BROOKS RECYCLED WATER PUMP STATION UPGRADES PROJECT
Solicitation Number: CO-00657
Job No.: 21-8601

ADDENDUM 2
September 27, 2023

SAN ANTONIO WATER SYSTEM
BROOKS RECYCLED WATER PUMP
STATION UPGRADE PROJECT
ONE LINE DIAGRAM II

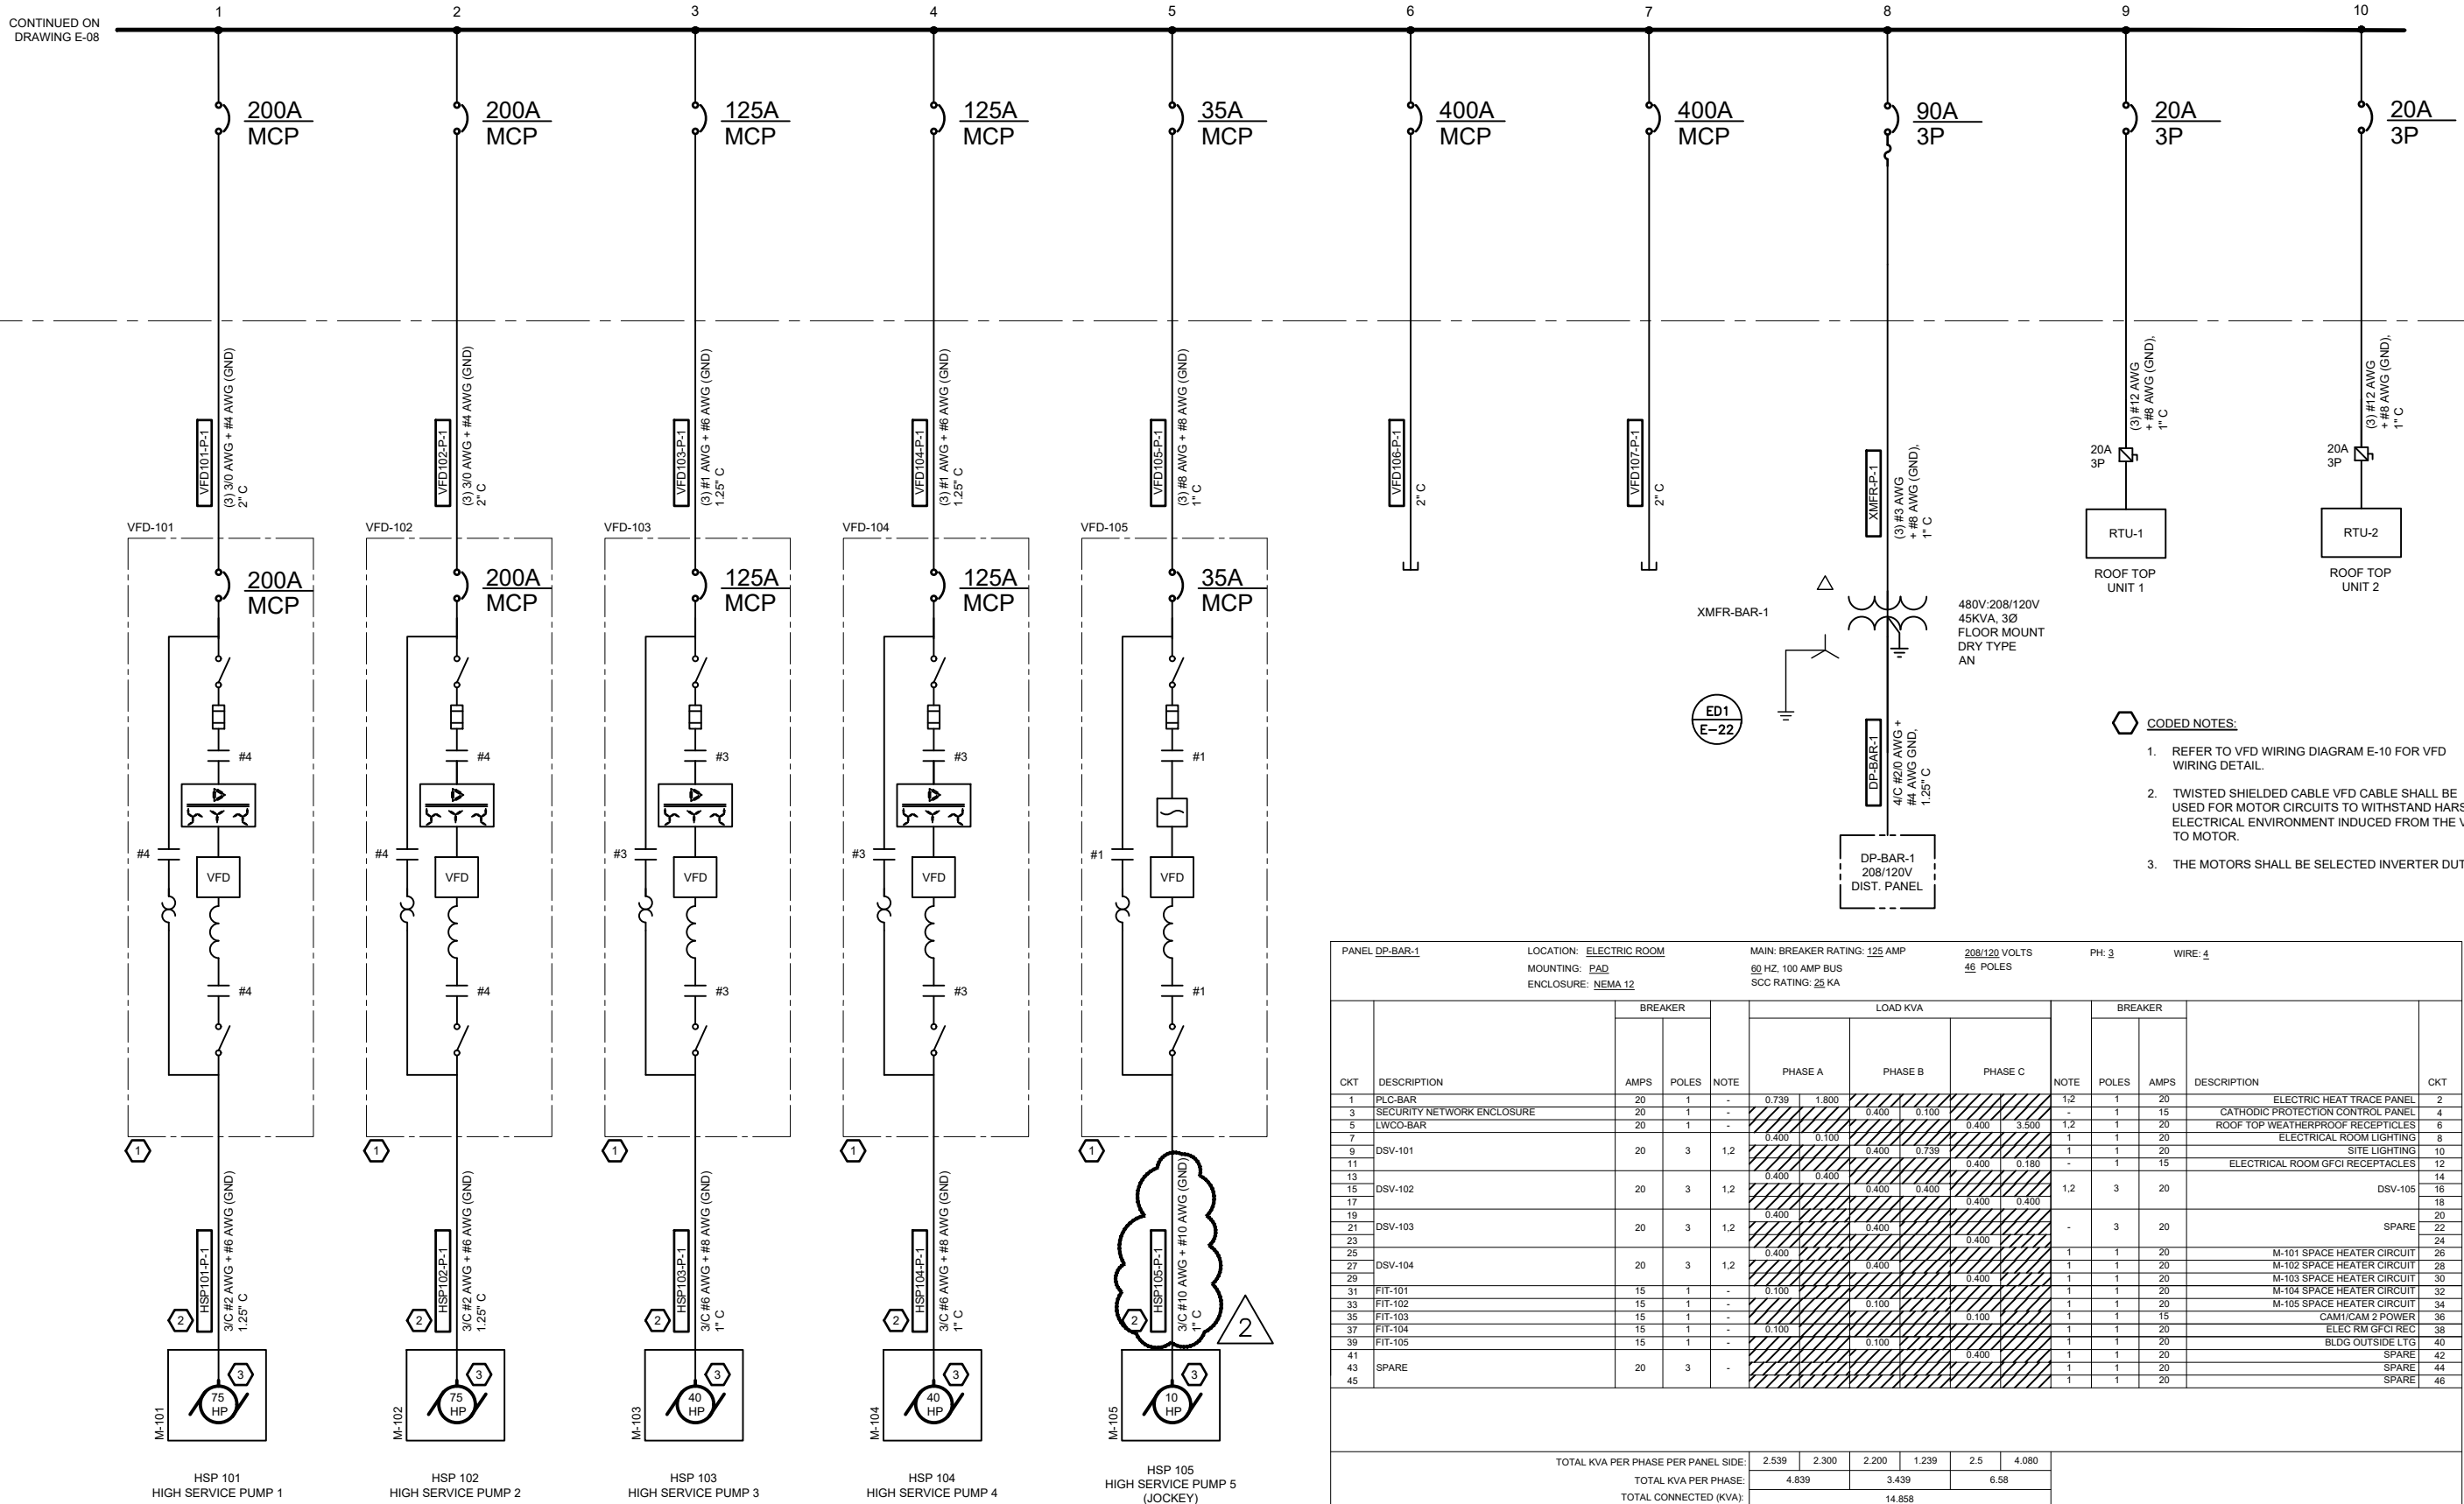
- 18. Question: Sheet E-09 conduit DP-BAR-1 from transformer XMFR-BAR-1 to panel DP-BAR-1 is showing to be in a 1-1/4" conduit, this does not meet the conduit fill requirement. Please review and revise.**

- 21. Question: HSP-101-P-1 feeder shown on E09 does not specify the wiring required. Please review and revise.**

Response: This conduit should be a 2-inch C. Please refer to Changes to the Plans No. 10 of this Addendum.

Response: The required wiring is 3/3C #10 AWG + #10 AWG (GND). Please refer to Changes to the Plans No.10 of this Addendum.
